Responses to Council Questions and Comments

3/18/2024

Item #4: Resolution Accepting Completion of the Petaluma Community Baseball Field Project by O.C. Jones & Sons, Inc.

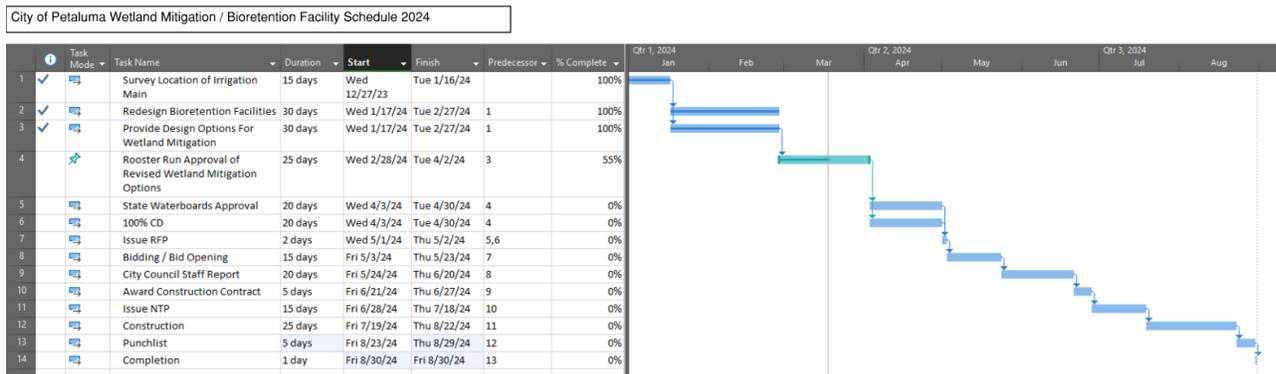
- Question: I went to site a week ago and it looks mostly finished but still missing benches for spectators and parking lot pavement. Also the wetland work and bioretention not done since removed from contract. Who will do this work at what cost? That raises the price tag over original budget again quite substantially with lots more time delay. Can we get a new schedule and costs estimate now before approving completion? Will we be allowing players on the field before the above amenities are completed?

Parking Lot Pavement: O.C. Jones installed the parking lot per the project plans, which consisted of 9 inches of compacted Class 2 Aggregate Base (AB) over 18 inches of lime treated soil, and concrete ADA spaces. Recently, the solar contractor was using heavy equipment in the area for solar canopy installation, this non-paved parking lot was not designed for heavy construction traffic which has caused some rutting and damage to the surface. The affected area will be recompacted and regraded in the coming weeks as the solar project nears completion. Staff has estimated the paving cost to be around \$150,000, and are actively seeking sources of available funding to complete the project.
